ZONING COMMITTEE STAFF REPORT

FILE NAME: 1346 Arcade St. LLC

FILE # 20-096-344

TYPE OF APPLICATION: Nonconforming Use Permit (Change & Expansion), Variance

Current Site Plan / Proposed Site Plan

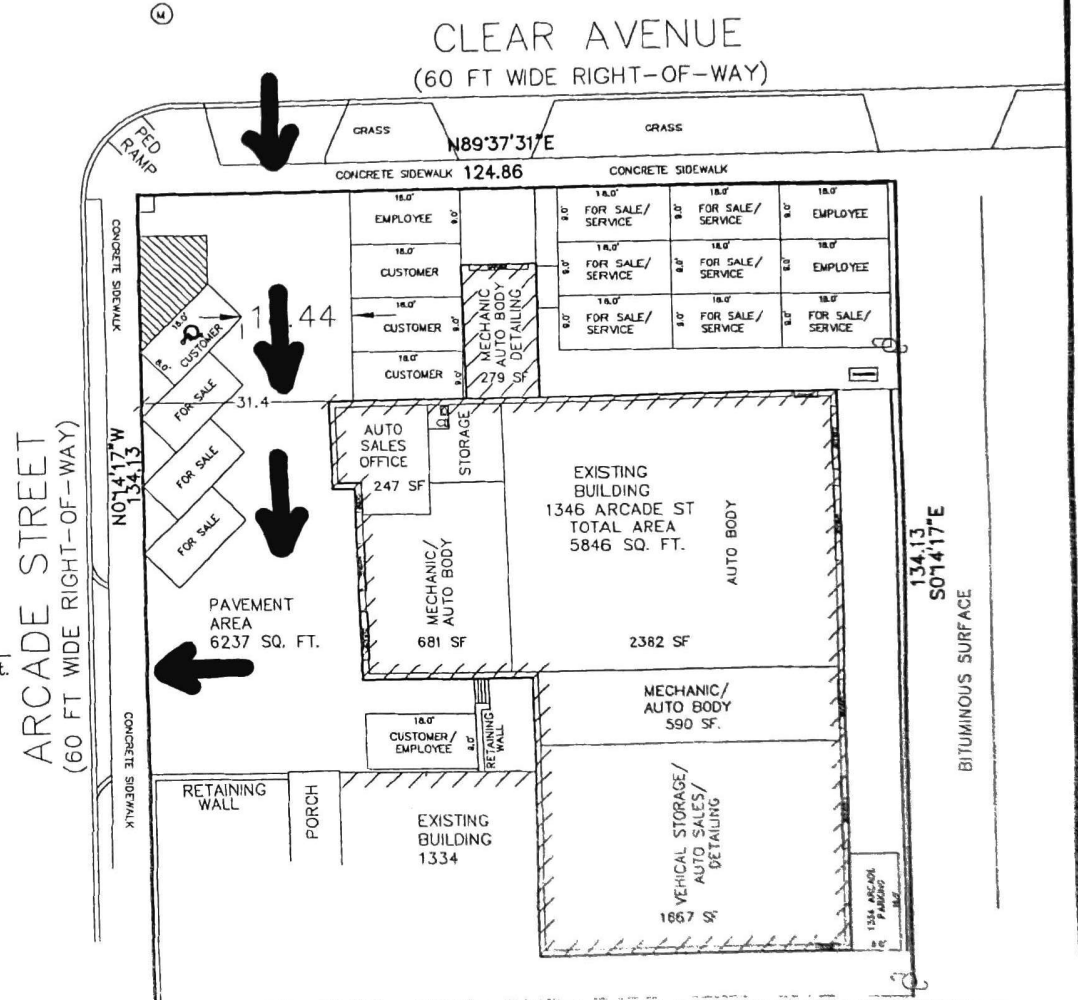
Without the additional spray booth on the north side of the building and with the garage addition used for parking, the parking requirement would be reduced to 18 spaces. With 8 parking spaces provided in the garage, the remaining 10 required parking spaces could be provided on the site north and west of the building, without a parking variance.

With about 34 feet at most between the existing building and public sidewalks along Arcade Street and Clear Avenue, there is only enough room for a one-way drive aisle and angled parking along the north and west sides of the building. The most efficient way to provide parking with this layout would likely be with a curb cut on Clear Avenue that meets the requirement for at least 60 feet of separation from the Arcade-Clear intersection, and the existing exit to Arcade. The existing curb cut close to the corner would just get in the way of having additional parking spaces there. It appears that 14-15 off-street parking spaces could be provided in this area without overhanging or maneuvering on the public sidewalks.

The application materials include photographs that appear to call into question the ability for a tow truck to maneuver through the site without using the curb cut on Clear closest to Arcade. However, any difficulty making this maneuver would be alleviated by elimination of the spray booth addition.

2. The spray booth addition on the north side of the building shall be removed.
 3. The Clear Avenue curb cuts within 60 feet of the Arcade-Clear intersection shall be removed and replaced with curbing.

4. Off-street parking on the site shall meet dimensional and design standards in the Zoning Code to the greatest extent possible, including the perimeter and screening landscape requirements in Zoning Code § 63.314 for parking facilities and outdoor auto sales adjoining public streets or sidewalks.

Staff Report Recommendation
4-9-2020

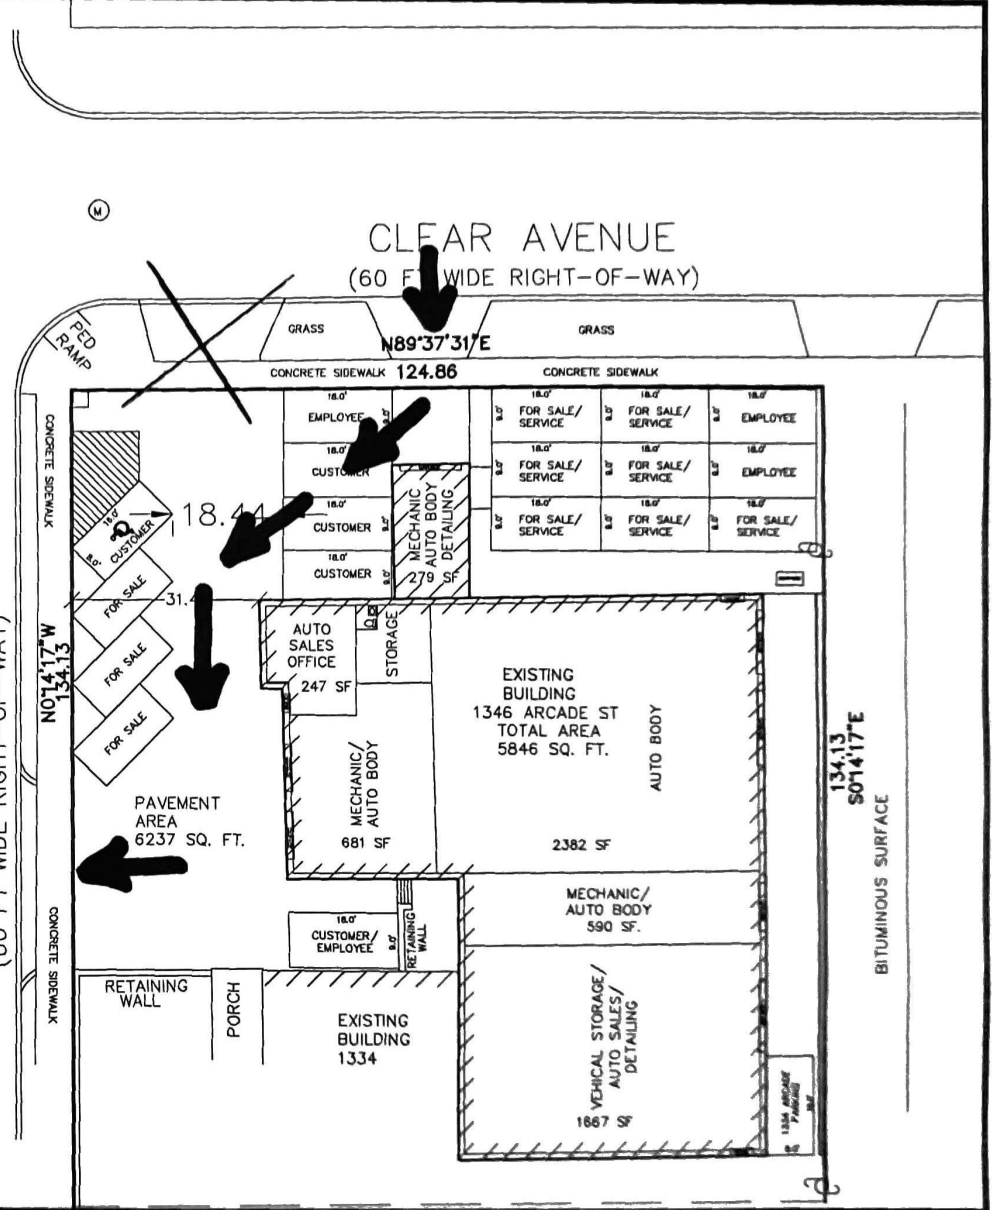
- J. **STAFF RECOMMENDATION:** Based on the above findings, staff recommends denial of the variances of required parking, landscaping and minimum distance between vehicular access and the Arcade-Clear intersection, and recommends approval of the change and expansion of nonconforming use to add auto repair and outdoor auto sales to existing auto body shop and dwelling on the site at 1334-1346 Arcade Street subject to the following additional conditions:

1. The garage addition behind the house at 1334 Arcade shall not be used for auto body or auto repair shop work, and must include at least one parking space to meet the parking requirement for the house.
